Block 16 Section 10

1.0 Context and Character

Functionality and build quality Lift Lobby

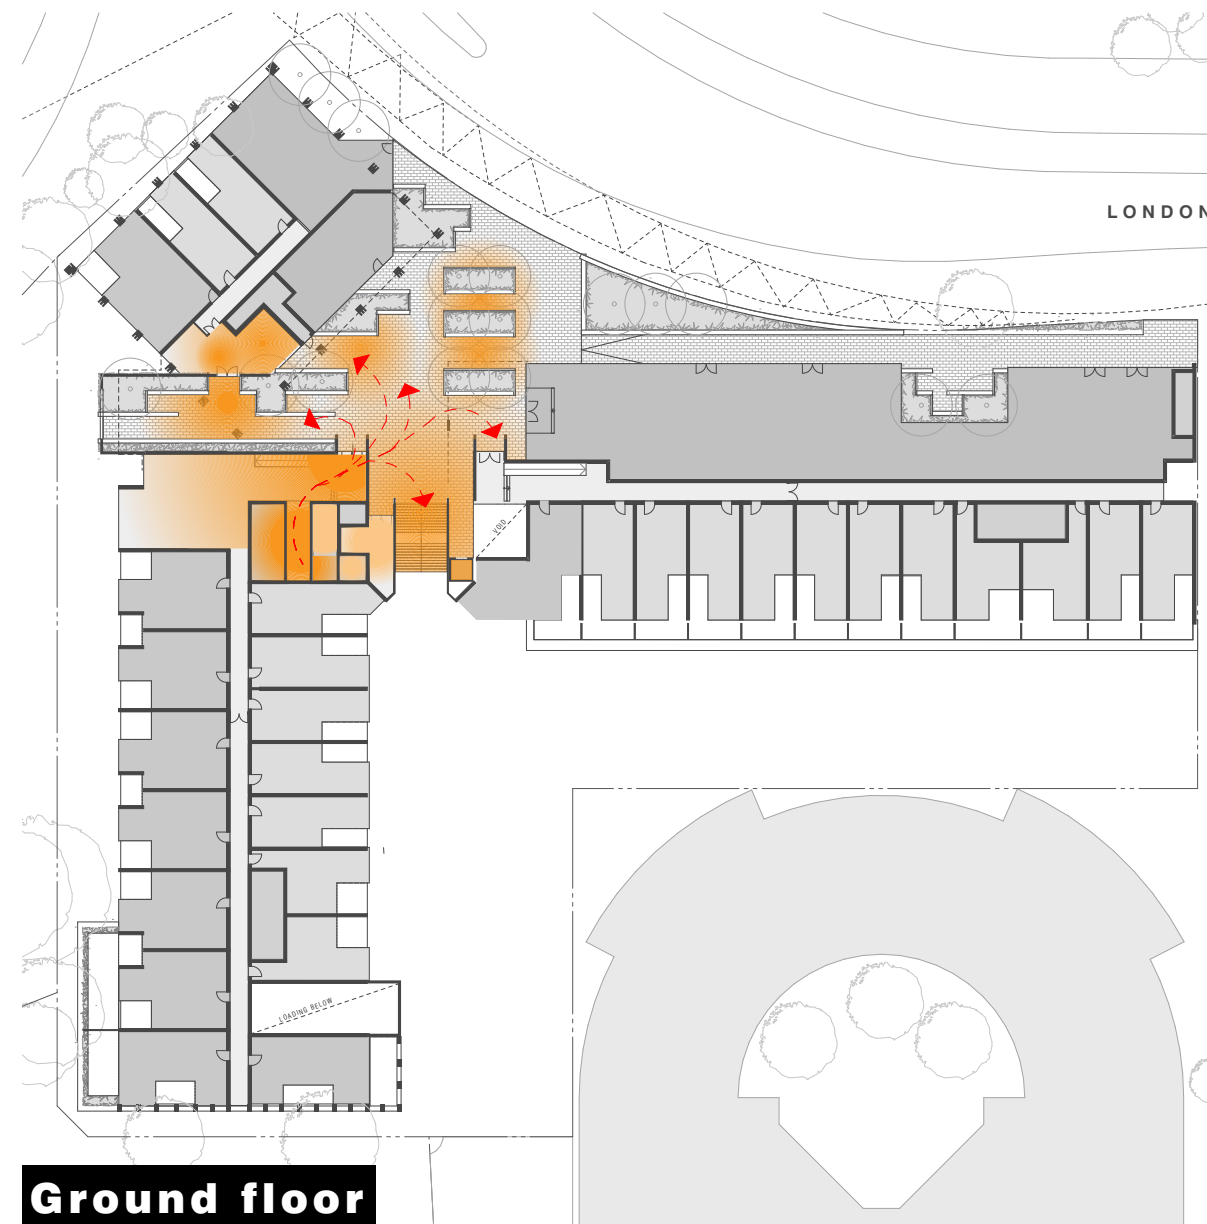
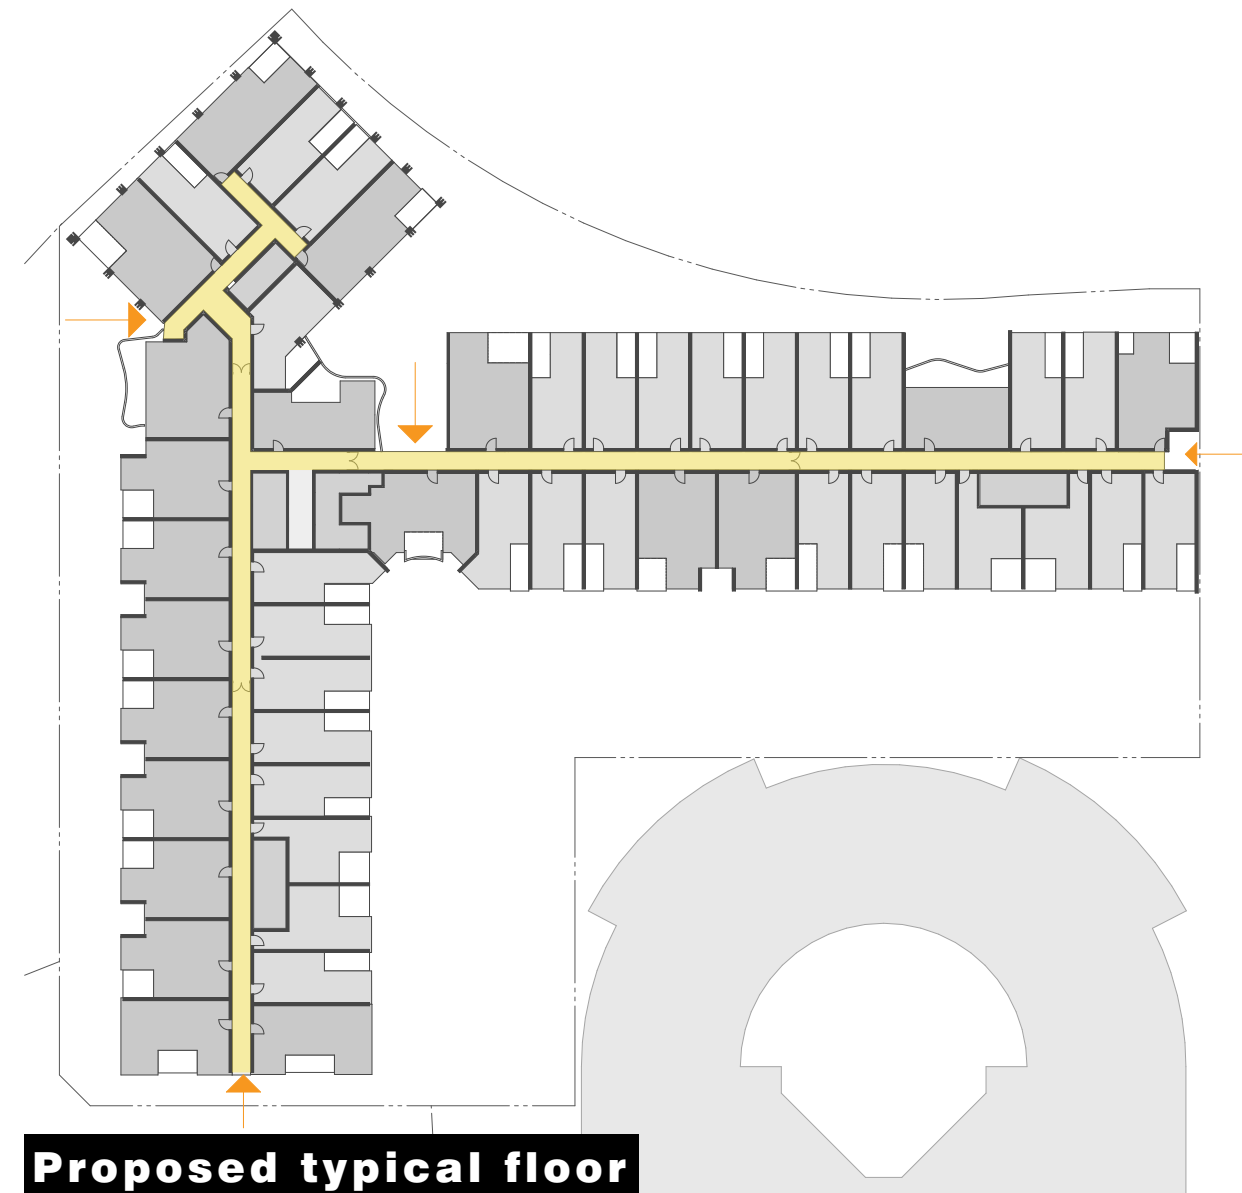
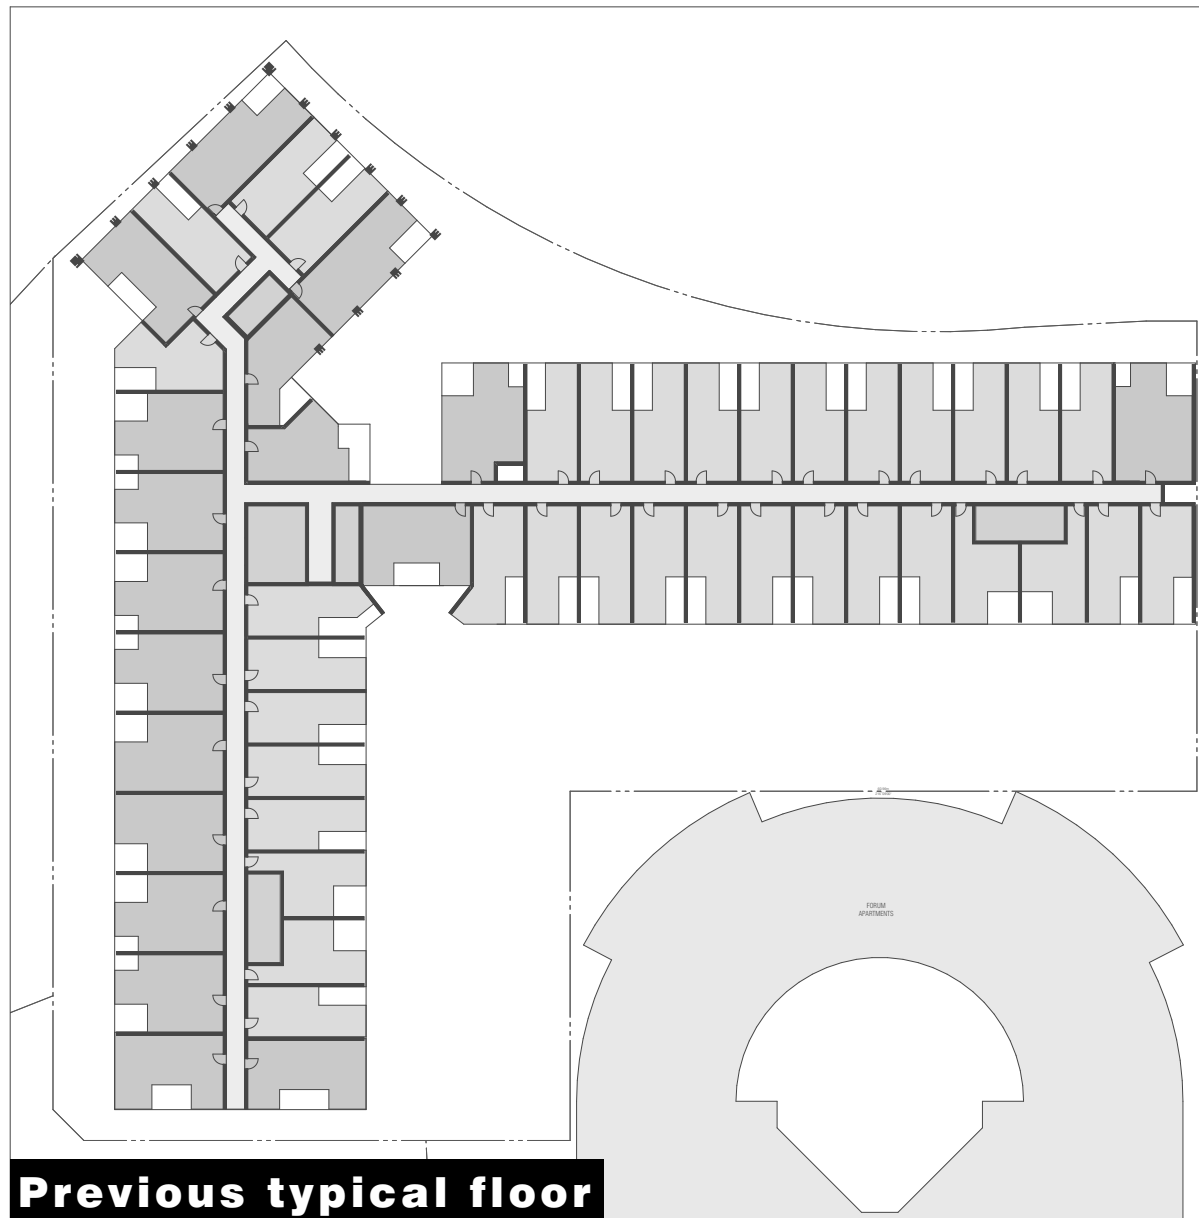
6.2 The Panel considers that the current proposal for a continuous building to London Circuit should show a higher degree of articulation than has been proposed to reduce the continuous frontage. Furthermore, the Panel considers that the current form, being serviced by a single lift lobby, has generated unacceptable internal corridor lengths and environments for future residents. The Panel encourages the proponent team to explore opportunities for a multiple lift core arrangement to provide appropriate levels of occupant access and amenity which may in turn facilitate greater opportunity of apartment amenity. The Panel recommends that this includes the consideration of natural daylighting to the internal corridors which will assist in providing way finding and comfortable internal environments for the residents.

6.2 The Panel considers that the current proposal for a continuous building to London Circuit should show a higher degree of articulation than has been proposed to reduce the continuous frontage. Furthermore, the Panel considers that the current form, being serviced by a single lift lobby, has generated unacceptable internal corridor lengths and environments for future residents. The Panel encourages the proponent team to explore opportunities for a multiple lift core arrangement to provide appropriate levels of occupant access and amenity which may in turn facilitate greater opportunity of apartment amenity. The Panel recommends that this includes the consideration of natural daylighting to the internal corridors which will assist in providing way finding and comfortable internal environments for the residents.

Legibility and safety Allara street address

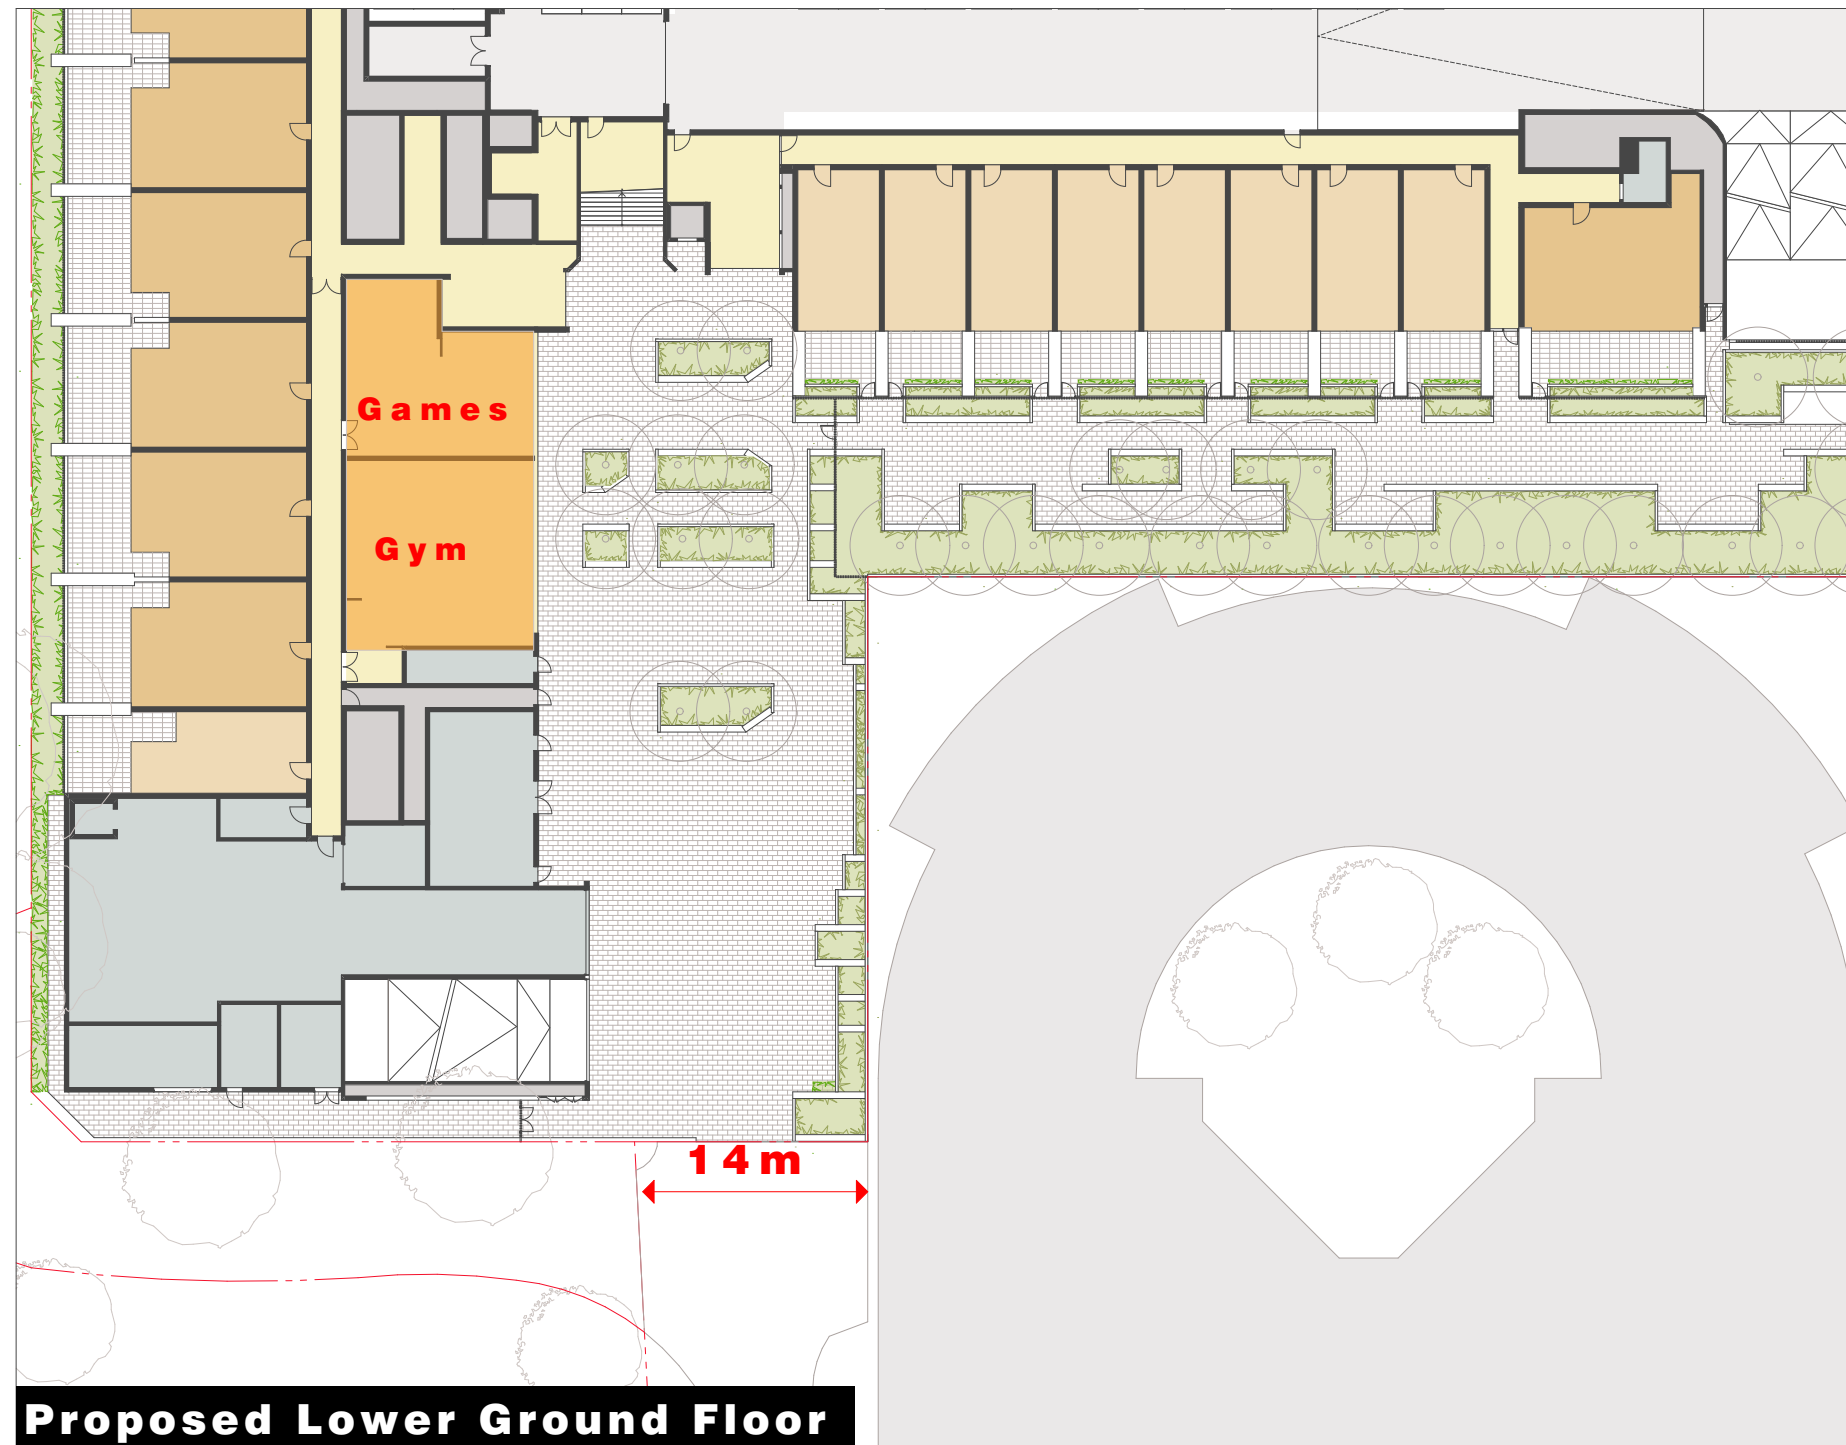
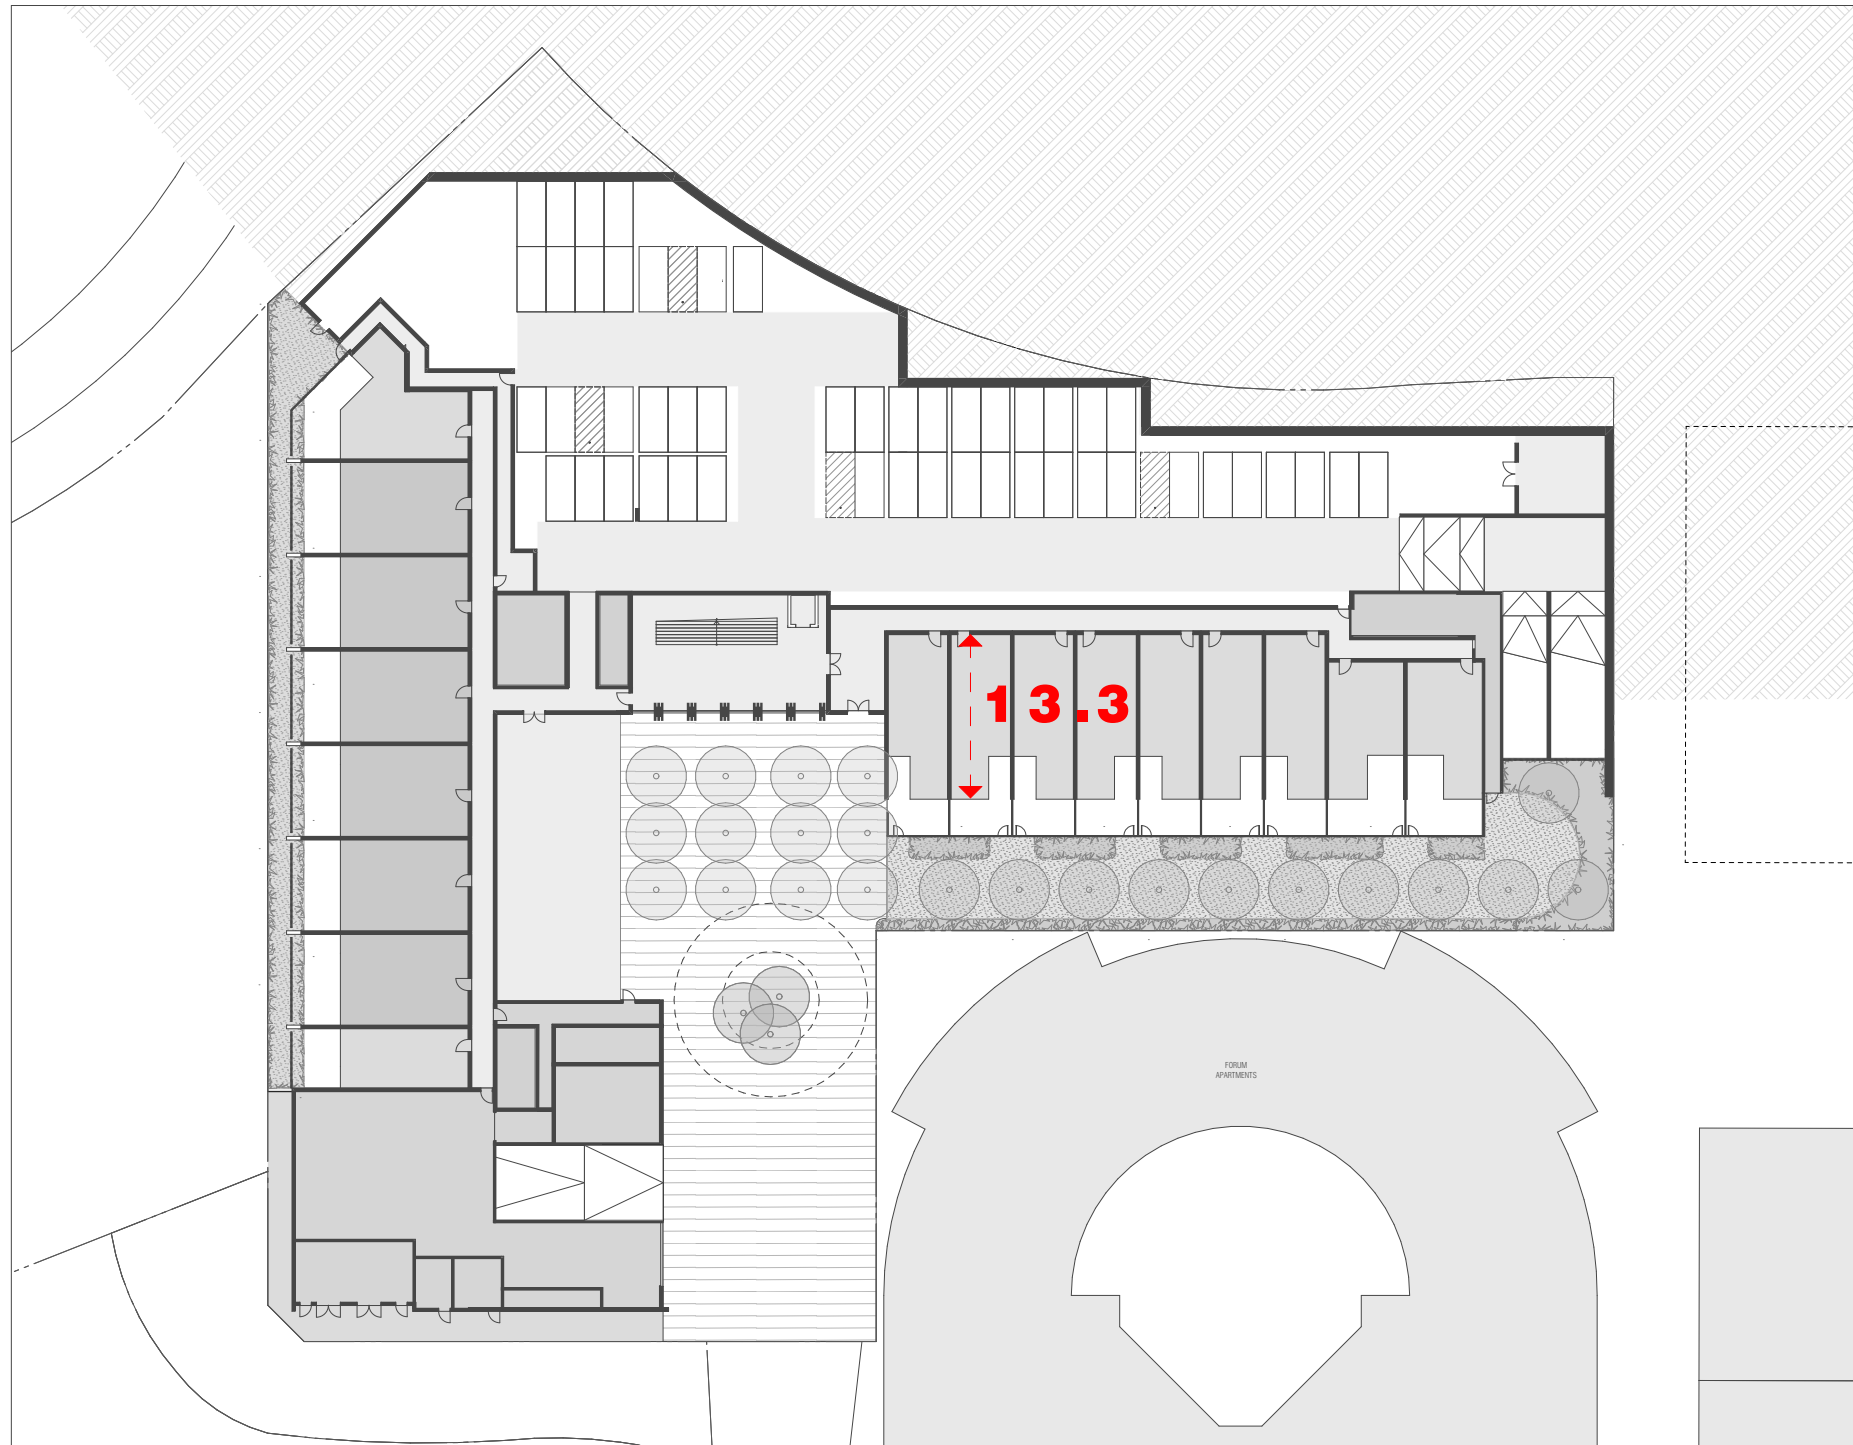
7.1 Improvements to the vehicle and service arrangement at the Allara Street entry are acknowledged by the Panel, however, further opportunities for celebration of the through connection remain. The proponent team is encouraged by the Panel to consider opportunities for sleeving of the service hub with active uses that may include the introduction of additional commercial use and/or residential lobby access.
